**RE: Adequacy Review No. 3, TR-9, Water Level Change and Pit Drain Evaluation Report,
Review Memo, NCCI Pit #1, File No. M2001-107**

On November 17, 2023, J & T Consulting, Inc. responded to the Division's Adequacy Review No. 2 dated October 31, 2023 for TR-9 at the NCCI Pit #1, permit no. M2001-107. Below is my review of the responses and additional questions/comments. The numbered items below correspond to the numbered items in the November 17th document.

Attachment 1

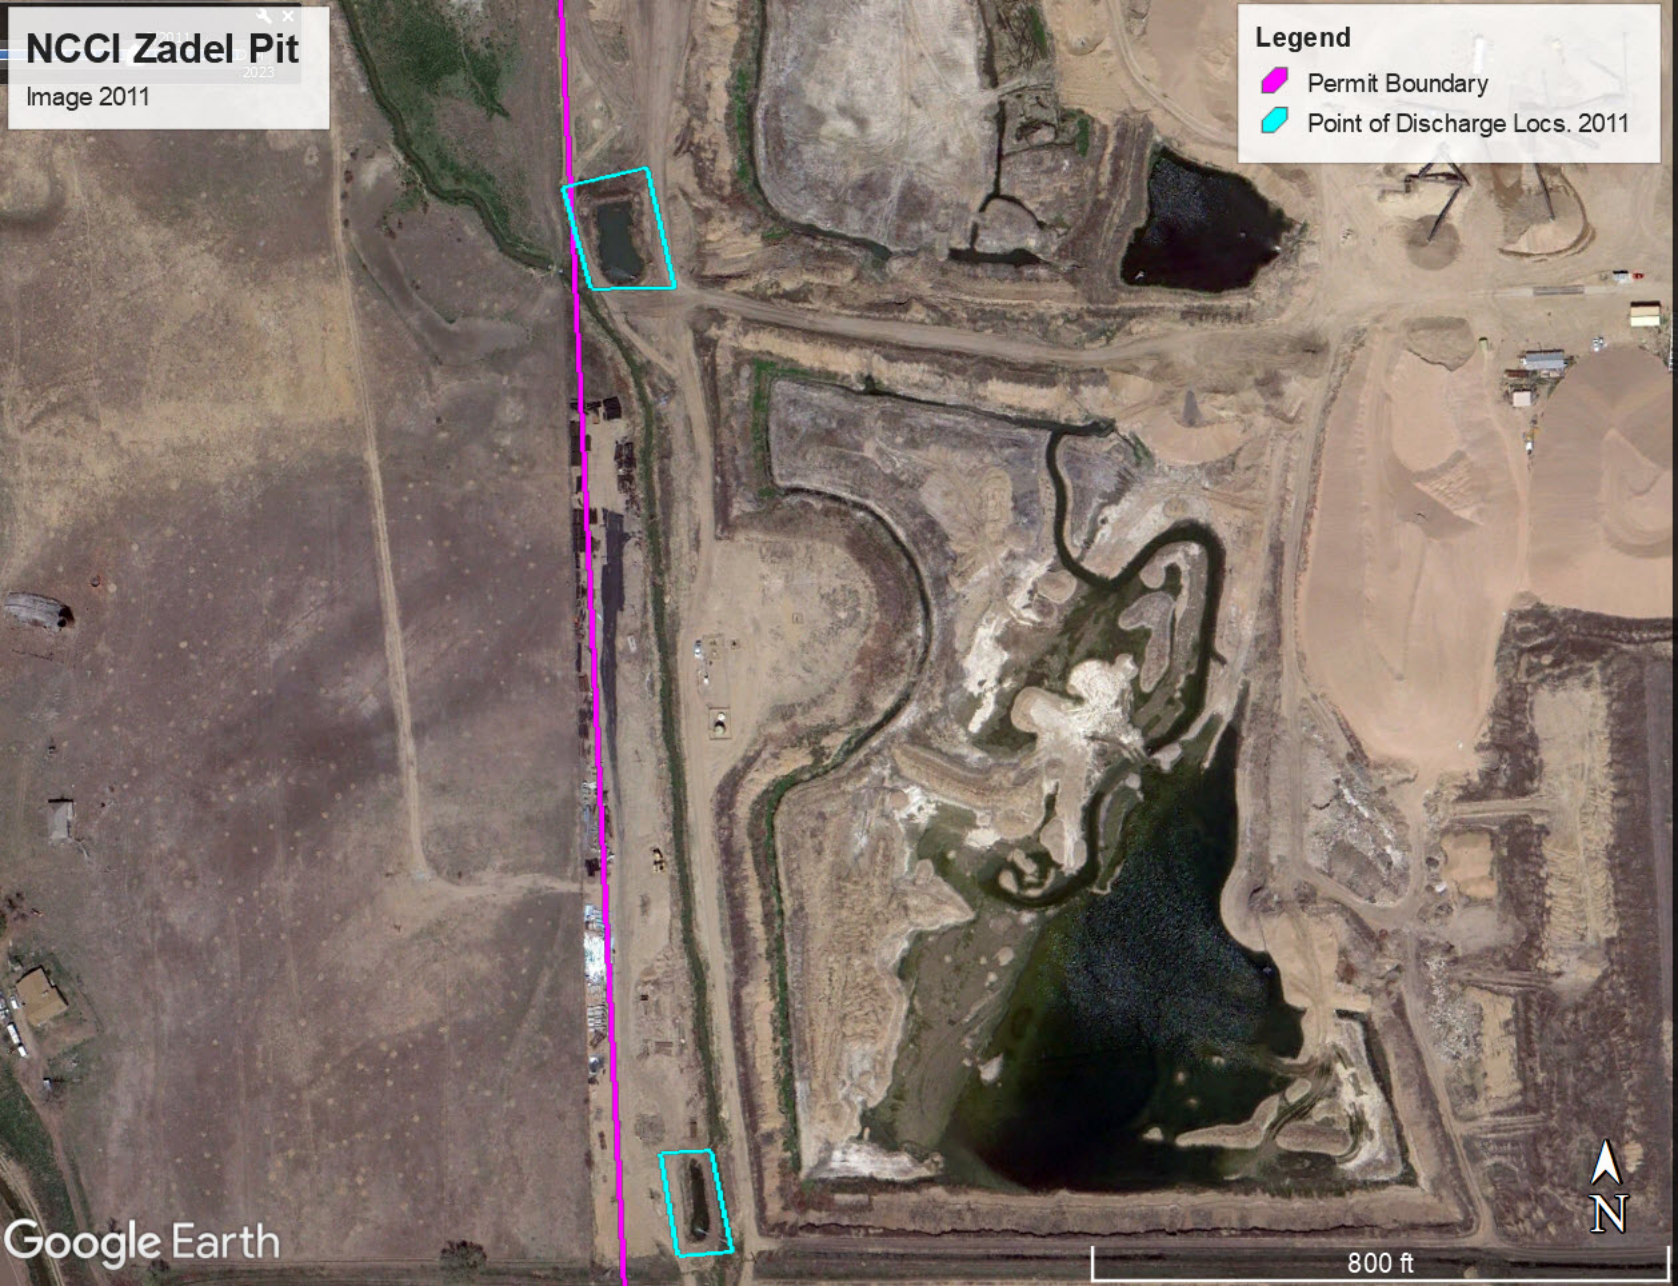
While there was ponding near and around the site that ponding has significantly increased over time. Please provide a map of the historical discharge points used during dewatering and the time frames when they were used. The Division's review of aerial imagery indicates two points were being used as discharge areas in 2011 south of the area in question (Attachment 1). In 2008, there appears to be a ditch that was installed to drain operations to the east along with direct discharge to LDC further south (Attachment 2). While ponding conditions may have existed prior to the initiation of mining operations those operations have negatively exacerbated the pre-existing conditions.
